KEY - SECTION 4.55 APPLICATION
PROPOSED MODIFICATION

REV DATE DESCRIPTION A 25.08.21 FOR DEVELOPMENT APPLICATION B 04.02.22 FOR SECTION 4.55 APPLICATION

PROJECT PACIFIC RD HOUSE 9 PACIFIC RD PALM BEACH NSW LOT 402 D.P 19651 CLIENT

PROJECT NO. DRAWING TITLE PA009 COVER SHEET

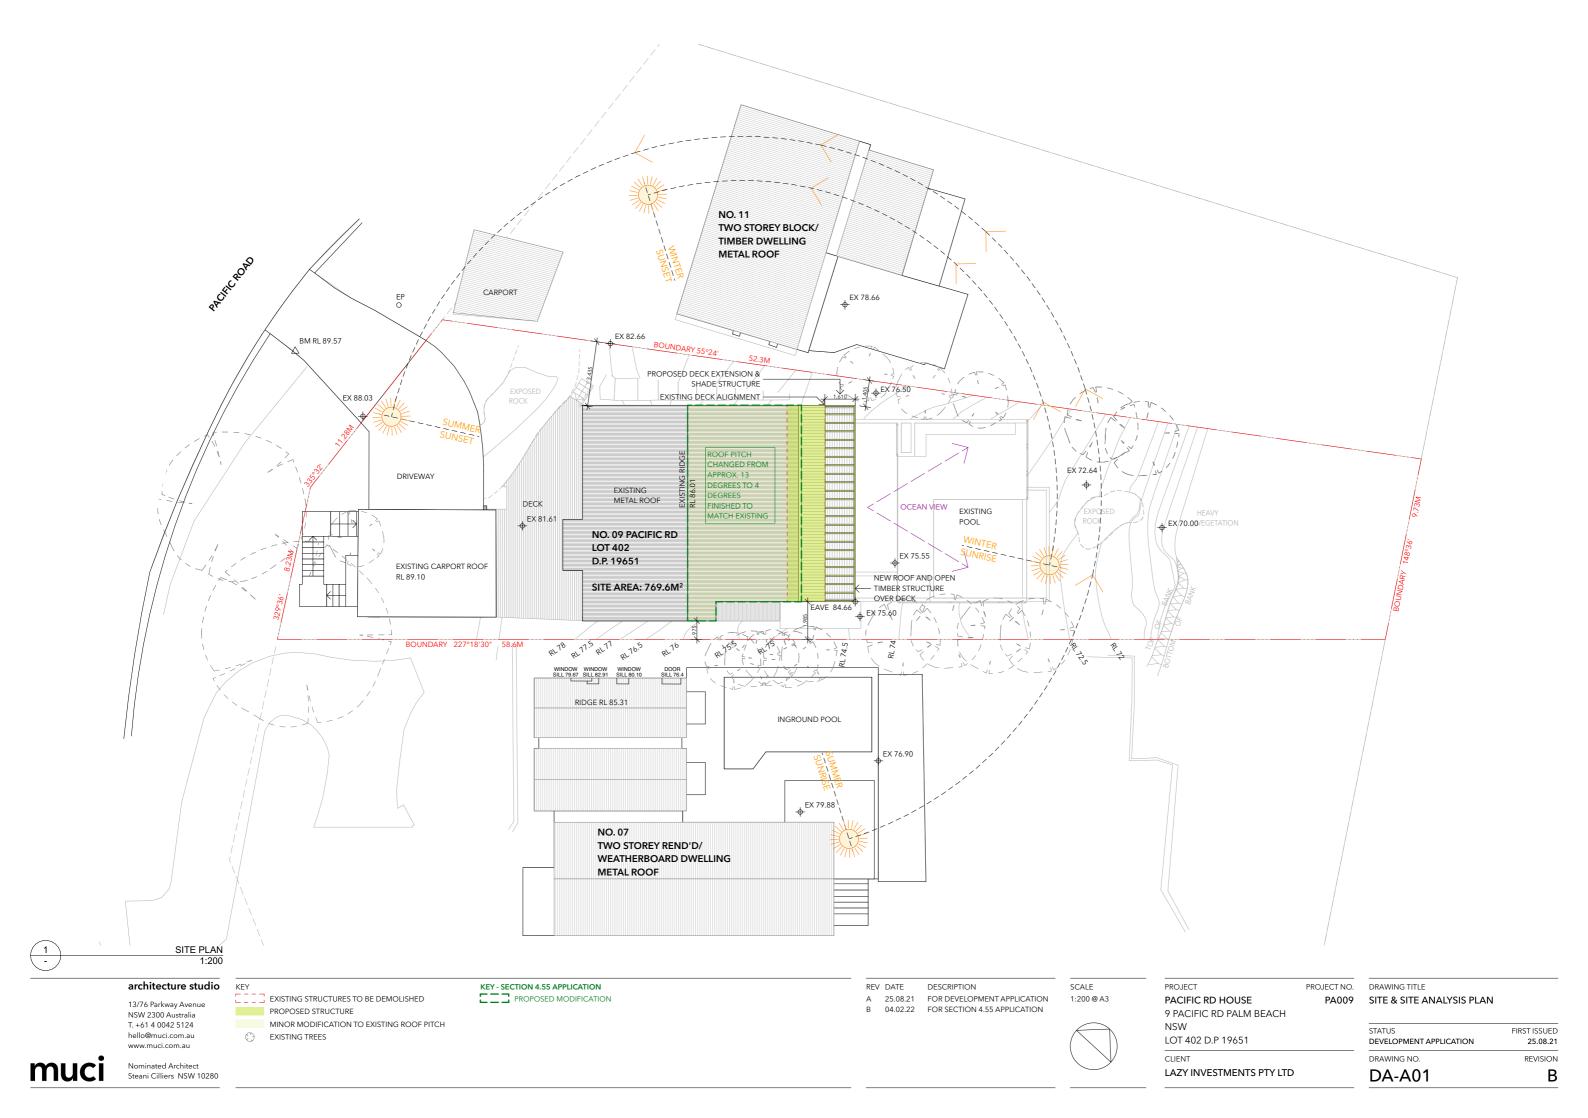
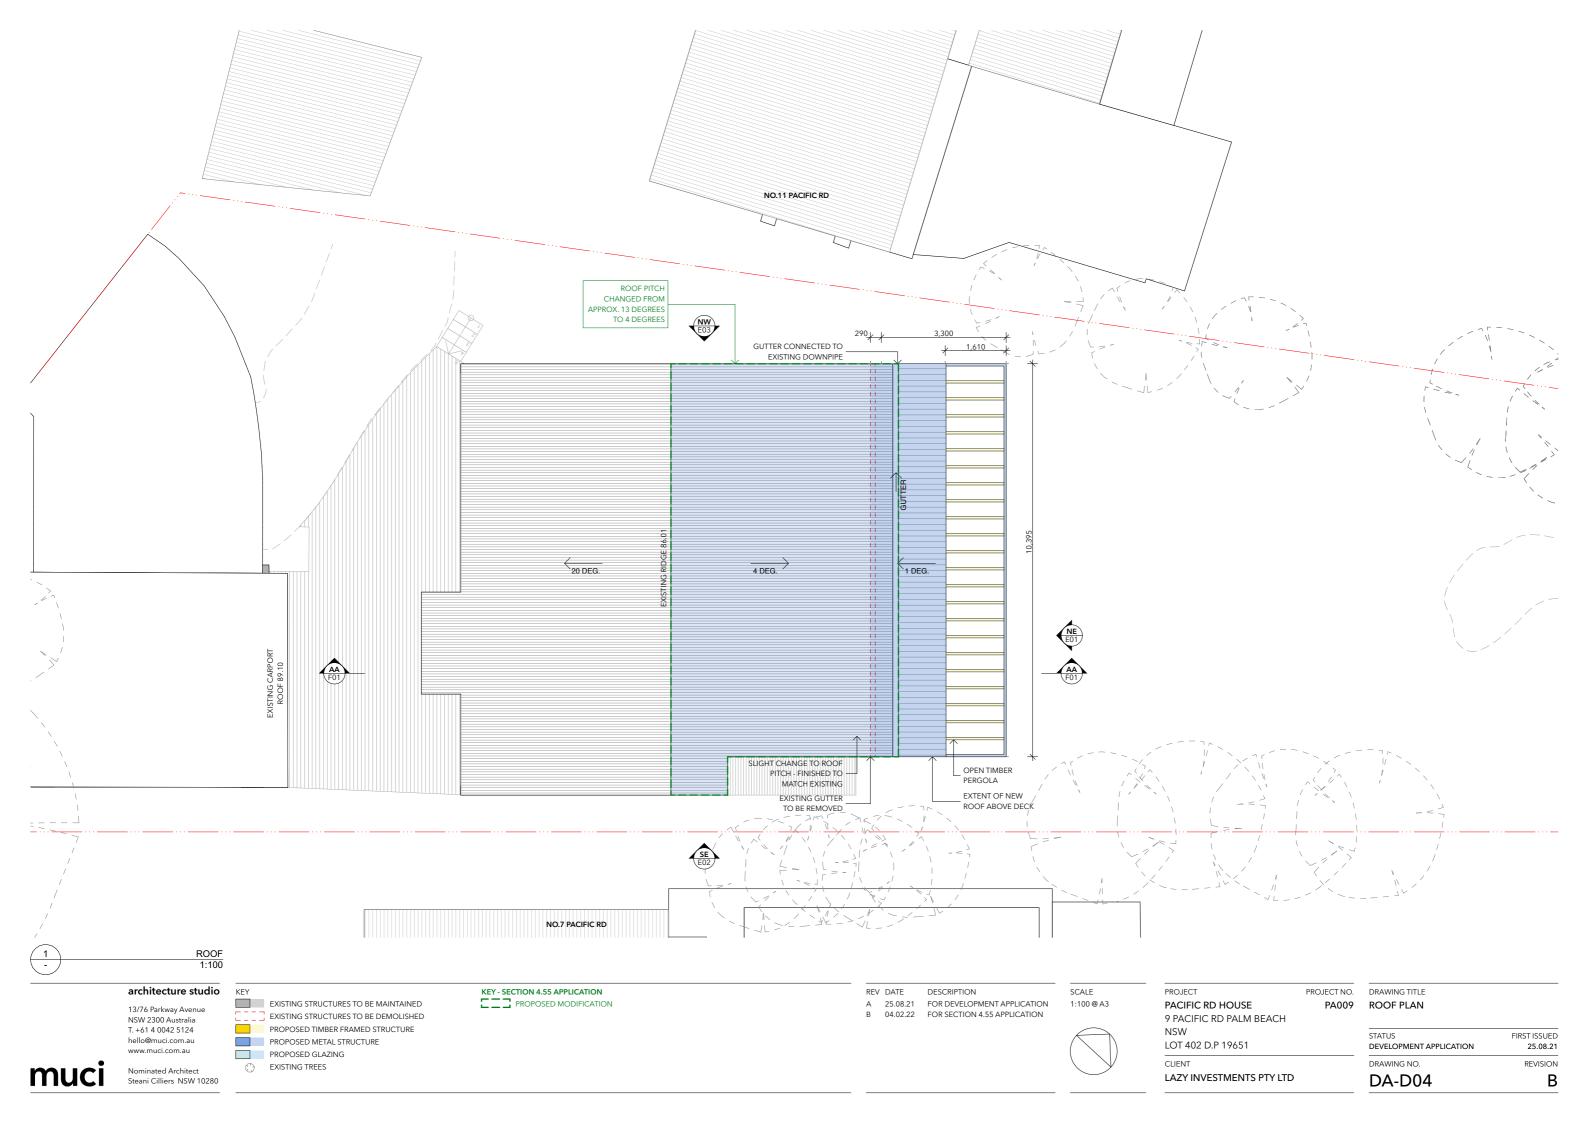
WINDOW ADDED

PROJECT NO. DRAWING TITLE PA009 SOUTH EAST ELEVATION

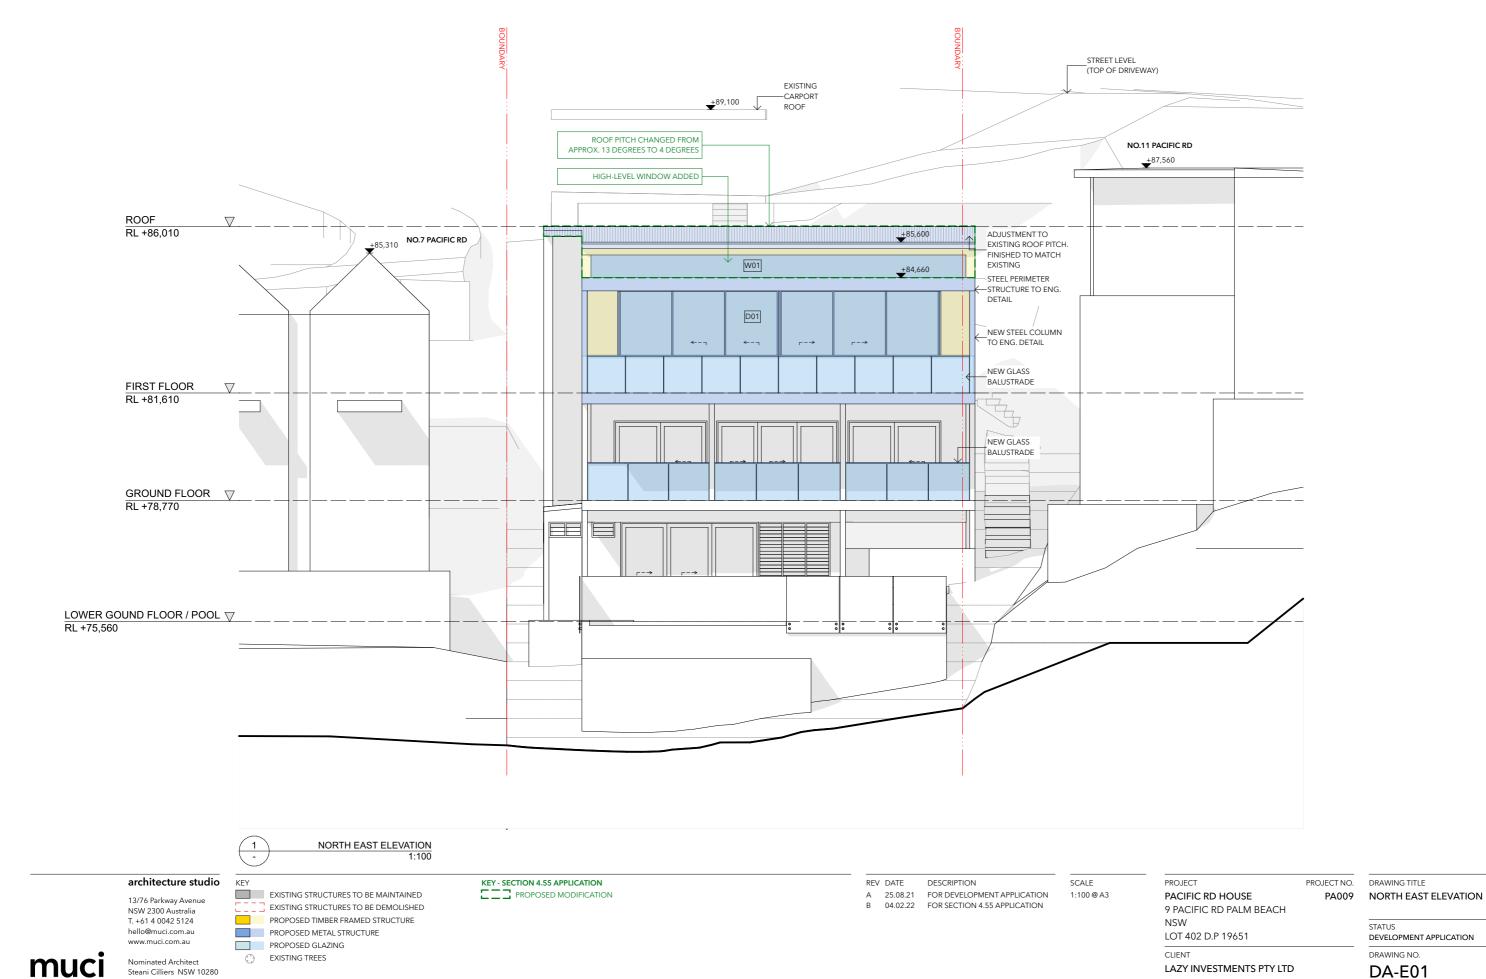
ROOF PITCH CHANGED FROM APPROX. 13 DEGREES
